UNITED STATES PATENT AND TRADEMARK OFFICE

APPLICATION NO.	FILING DATE	FIRST NAMED INVENTOR	ATTORNEY DOCKET NO.	CONFIRMATION NO.
10/796,359	03/09/2004	John Riley Hawkins	DEP5260	2263
27777	7590	09/18/2008		
PHILIP S. JOHNSON JOHNSON & JOHNSON ONE JOHNSON & JOHNSON PLAZA NEW BRUNSWICK, NJ 08933-7003			EXAMINER RAMANA, ANURADHA	
			ART UNIT 3733	PAPER NUMBER
			MAIL DATE 09/18/2008	DELIVERY MODE PAPER

Office Action Summary

DETAILED ACTION

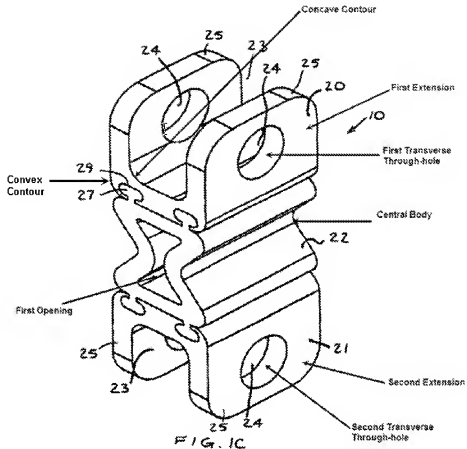
Duncan, Jr. discloses a device including: a central body 12; a first extension 10 separate from the central body; a second extension 11 separate from the central body; and a rivet 13 wherein a first portion of the rivet is integral with one of the extensions and a second portion of the rivet is integral with the other of the extensions wherein the rivet is located in a lower half of the extensions (Figs. 2 and 6, col. 1, lines 37-68 and col. 2, lines 1-67). Note that the rivet is in the lower half of the extensions wherein the lower half is defined by a longitudinal axis of each extension. Also, see marked up Fig. 3 from Duncan, Jr. below.

Duncan, Jr. clearly discloses first and second extensions, each extension having an upper end, a lower end, an inner surface having a convex contour and an outer surface having a concave contour as illustrated in marked up Fig. 3, provided earlier in this action. The inner concave contour follows the outer convex contour and at least a portion of the inner concave contour shares a common center of curvature with the outer convex contour.
